CITY OF ALBUQUERQUE

RE: 2706 Campbell Rd. NW
Engineer's Certification Date: 09/24/23
Engineer's Stamp Date: 04/28/23
Hydrology File: G12D041

Based upon the information provided in your submittal received 09/26/2023, the Grading and Drainage Plan is approved for Building Permit and Building Pad Certification for 2706 Campbell Rd. NW. Please attach a copy of this approved plan in the construction sets for Building Permit processing along with a copy of this letter.

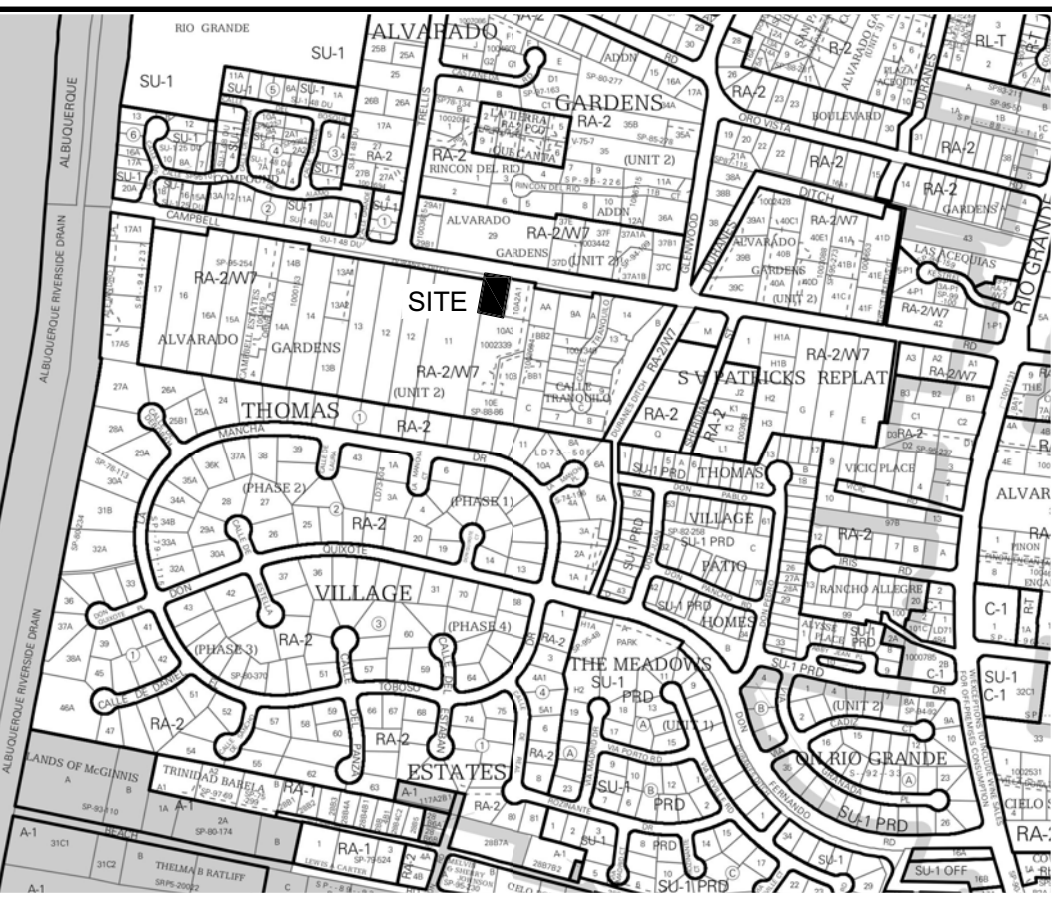
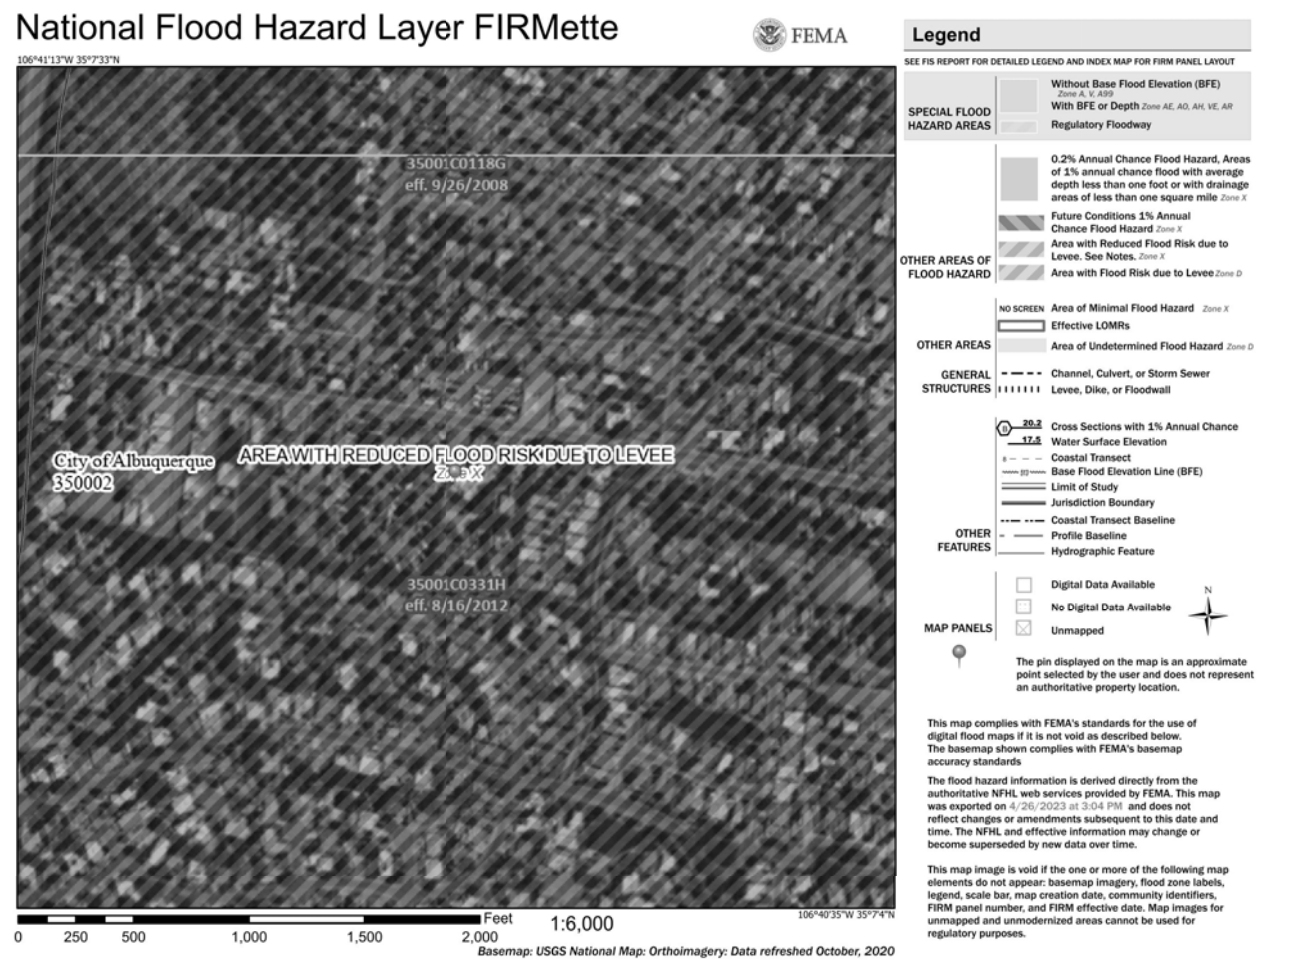
1. Engineer's Certification, per the DPM Part 6-14 (G): Engineer's Certification Checklist for Subdivision and Part 6-14 (H): Required Certification Language is required.
